MEMORANDUM

TO: Howey-in-the-Hills Planning Board
CC: D. Burke, Town Clerk
FROM: Thomas Harowski, AICP, Planning Consultant
SUBJECT: Venezia Lot 133 Swimming Pool Variance
DATE: October 28, 2019

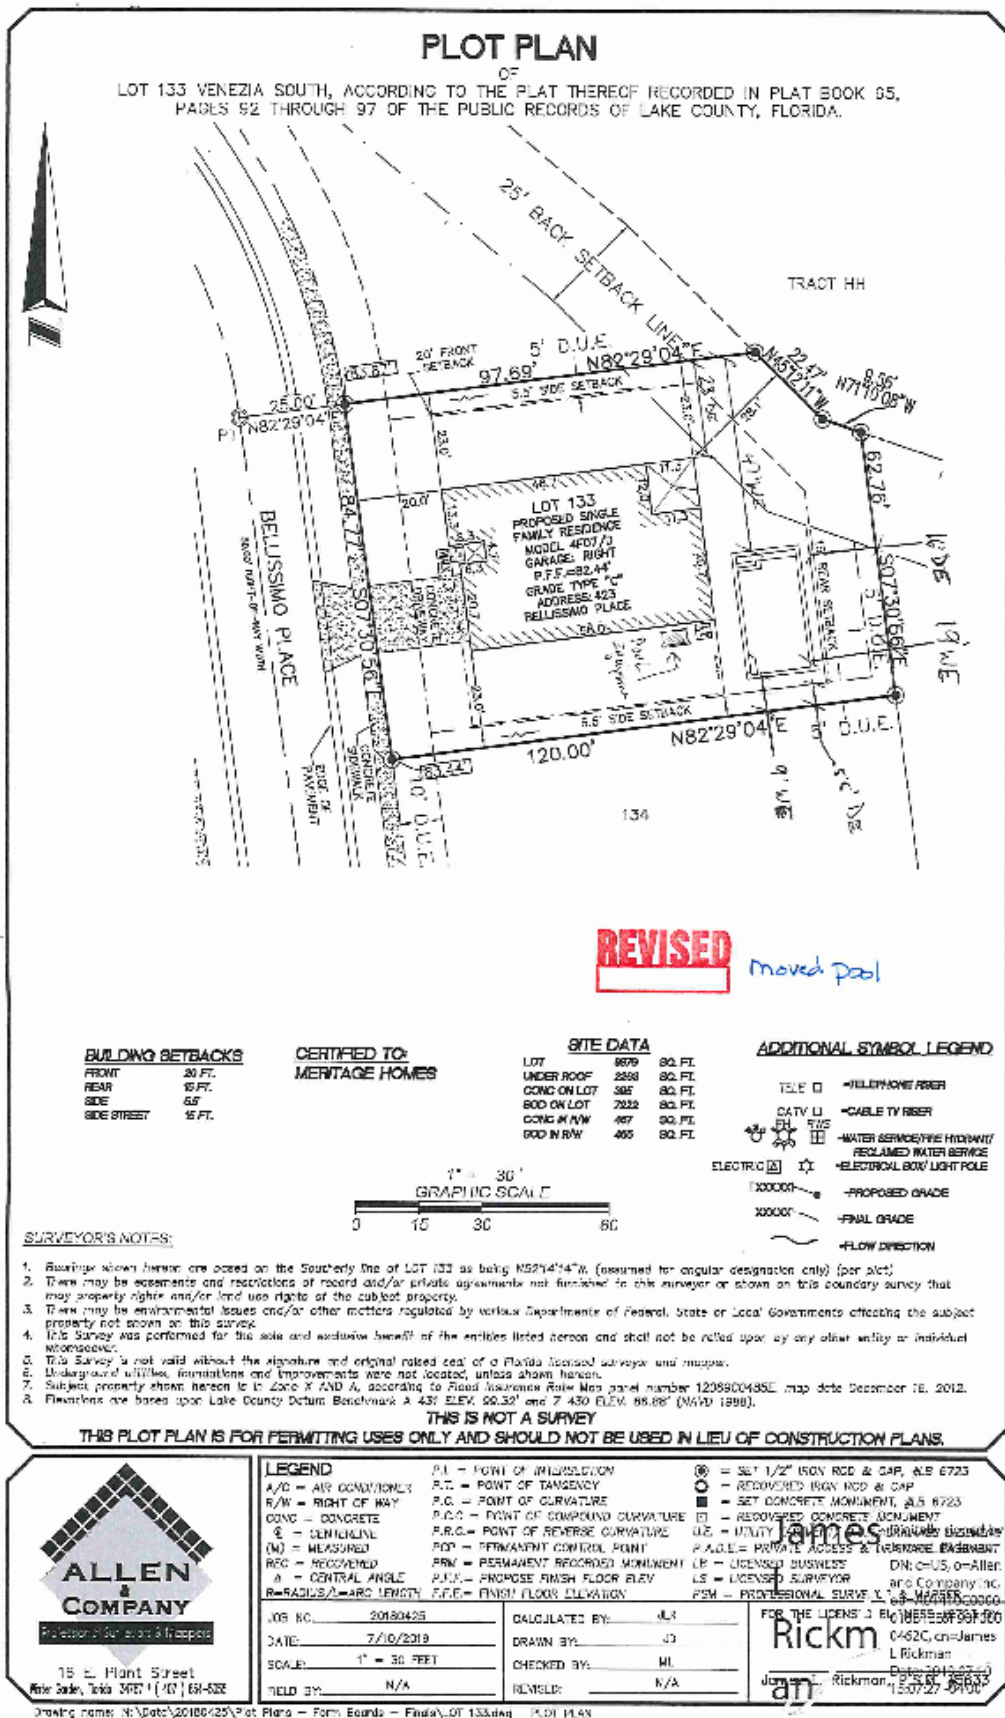
While there may be supporting evidence to allow some relief from the side yard setback requirements for the pool deck and pool enclosure, it is apparent from the survey provided that the swimming pool itself could be shifted one foot to the north to comply with the setback requirements of Section 5.01.08 of the land development code. Additionally, any variance is to be the minimum relief needed to allow for utilization of the property. The applicant should provide evidence that the request variance of 4.5 feet is the minimum necessary to allow for the swimming pool to be constructed and to be useable by the residents.

Staff recommends the Planning Board advise the Town Council of its recommendation for a variance of 4.5 feet from the required 10-foot side yard setback to allow the pool deck and pool enclosure be constructed 5.5 feet from the side property line. This recommendation is contingent upon the applicant demonstrating to the Planning Board that the 4.5-foot variance is the minimum variance necessary to allow for construction of and full use of the proposed pool. Staff does not recommend any variance for the pool setback.
